City of Keene Planning Board

AGENDA

Monday, May 22, 2023

SPR-967, Modification #7A – Site Plan Review – Railroad Land Landscaping Modifications – 0 Cypress St

RAILROAD SQUARE DEVELOPMENT
 KEENE, NEW HAMPSHIRE
 SITE LANDSCAPING PLAN

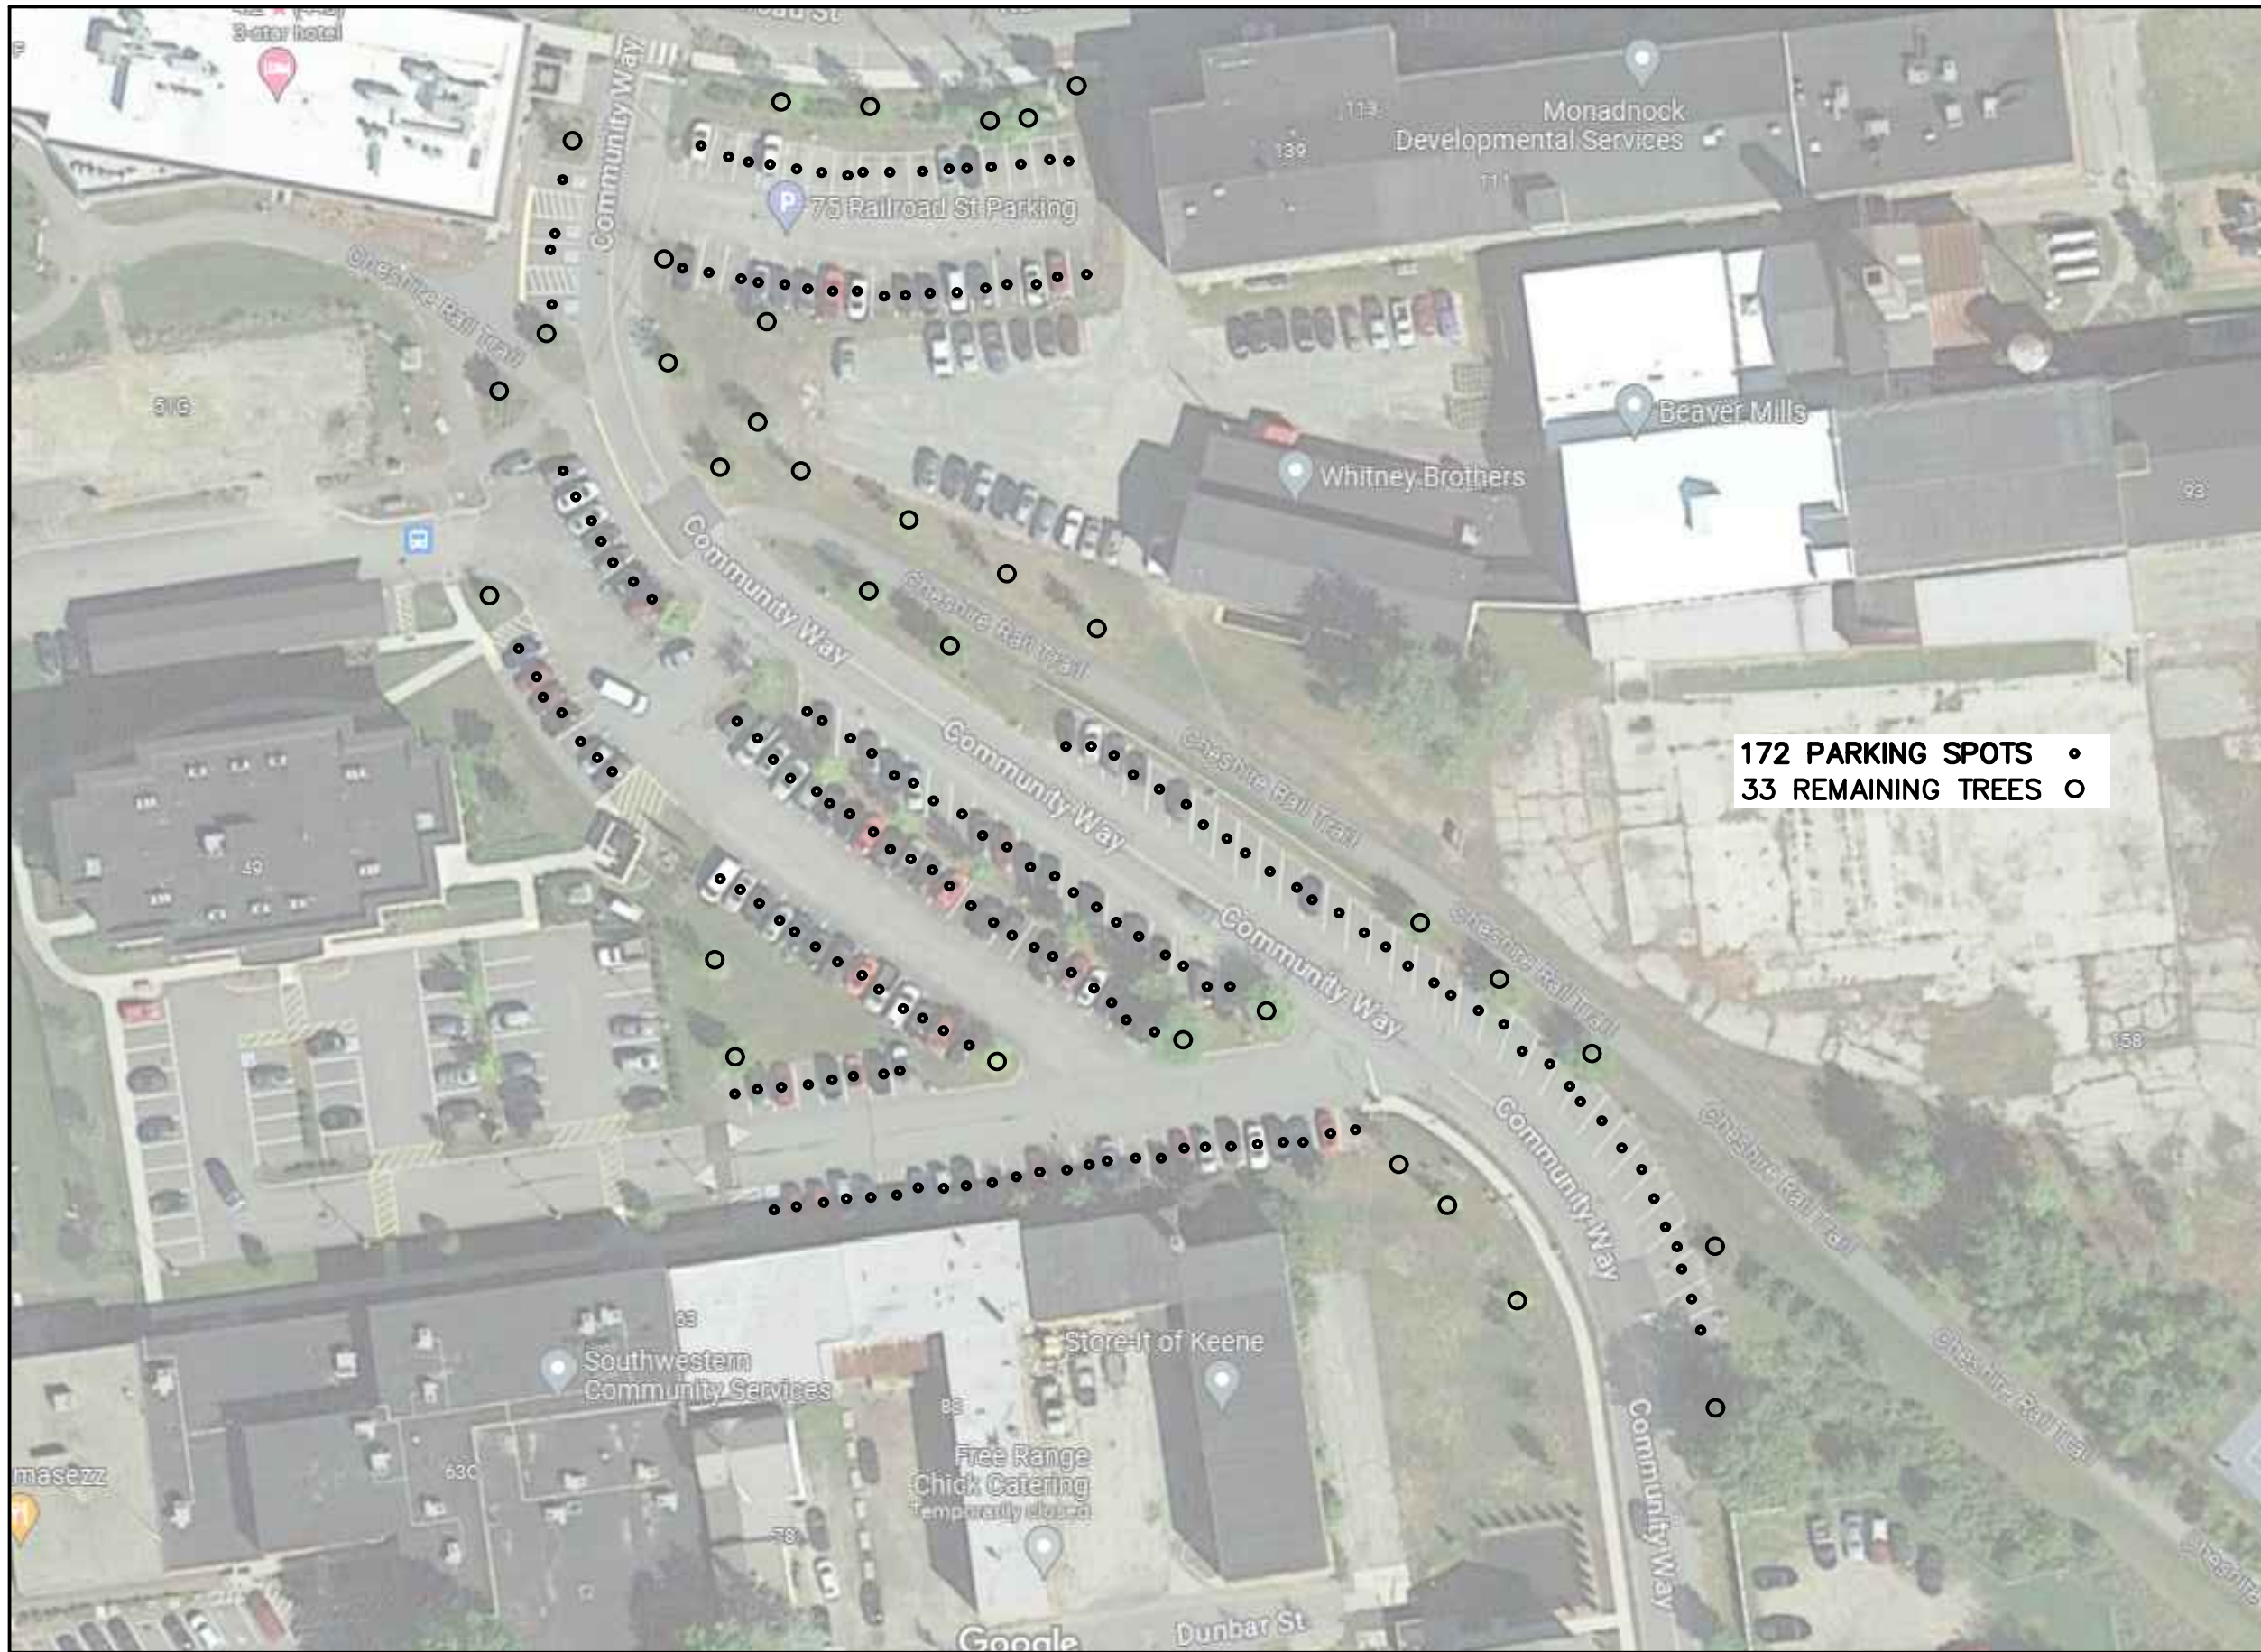
Figure 2. Snippet of the approved landscaping plan from SPR-967 with the location of the seven trees that were removed along Community Way circled in red.

20.5 - Landscaping. The Applicant is proposing to replace seven existing trees that were removed in two interior landscaping islands on the eastern portion of the site with 34 Dwarf Inkberry shrubs. Figure 2 shows an aerial view of the trees that were removed. Figures 3 & 4 show Google Street View imagery of the trees that were removed and Figure 5 shows one of the stumps that was left behind following the removal of the trees. The narrative that was submitted by the Applicant states that these trees never thrived and were removed because of this. In the narrative, the Applicant states that one possible reason that the trees failed to thrive could potentially be that the underlying surface of the former rail yard was not conducive to the

Fig 2: School building & addition, east facade – Phase 1

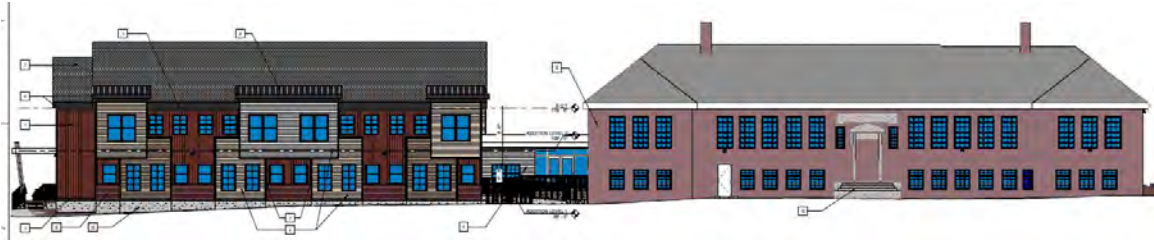
The exterior façade of the new construction will consist of vinyl board & batten, PVC trim, brick cladding, and vinyl clapboard. The applicant states in their narrative that, “The exterior of the building façade has been articulated to create an undulating pattern of mixed siding materials including board and batten, horizontal siding, trim and colors.” The Board will need to determine if this standard has been met.
